Access Compliance Report

Public Rights-of-Way

(Curb Ramps)

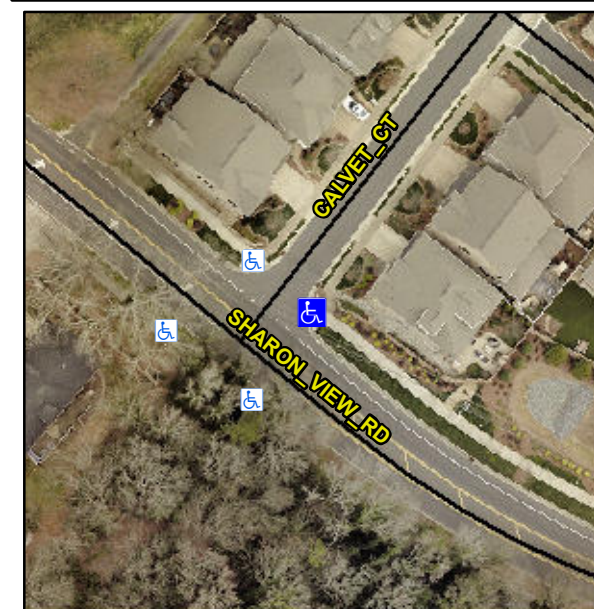
Intersection ID: 53124	Main Street: SHARON_VIEW_RD	Cross Street: CALVET_CT	Location: NE
ADA ID: E1BB319C6526	Ramp Type: PerpDiag	Initial Pass/Fail: Fail	Overall Compliance: No
Severity Score: 22.5			
Codes/Mitigation Info/Possible Solution		Field Measurements/Component Compliance

R304.5.1, R304.2.2, R304.5.3

Compliance	Description	Data	Compliance	Description	Data
N/A	Ramp Length (in)	71.0	No	Ramp Slope (%)	10.6
No	Ramp Width (in)	47.0	No	Ramp XSlope (%)	2.7
N/A	Flare Type LT	N/A	N/A	Flare Type RT	N/A
N/A	Flare Slope LT (%)	N/A	N/A	Flare Slope RT (%)	N/A
N/A	Flare Traversable LT?	N/A	N/A	Flare Traversable RT?	N/A
N/A	Landing Length (in)	N/A	N/A	DWS Provided?	N/A
N/A	Landing Width (in)	N/A	N/A	DWS Contrast?	N/A
N/A	Landing Slope (%)	N/A	N/A	DWS Length (in)	N/A
N/A	Landing X Slope (%)	N/A	N/A	DWS Full Width?	N/A
N/A	Landing Curb? (Y/N)	N/A	N/A	DWS Offset (in)	N/A
N/A	Shared Landing?	N/A			
N/A	Gutter Ponding?	N/A	N/A	Gutter Slope (%)	N/A
N/A	Gutter Lip Ht (in)	N/A	N/A	Gutter X Slope (%)	N/A
N/A	Painted X Walk1?	No	N/A	Painted X Walk2?	No
	X Walk 1 Direction	To NW		X Walk 2 Direction	To SW
N/A	X Walk 1 Width (in)	N/A	N/A	X Walk 2 Width (in)	N/A
	X Walk 1 Slope (%)	3.3		X Walk 2 Slope (%)	2.1
	X Walk 1 X Slope (%)	0.1		X Walk 2 X Slope (%)	3.4

Remove & Replace Curb Ramp With Two New Directional Ramps or Equivalent.
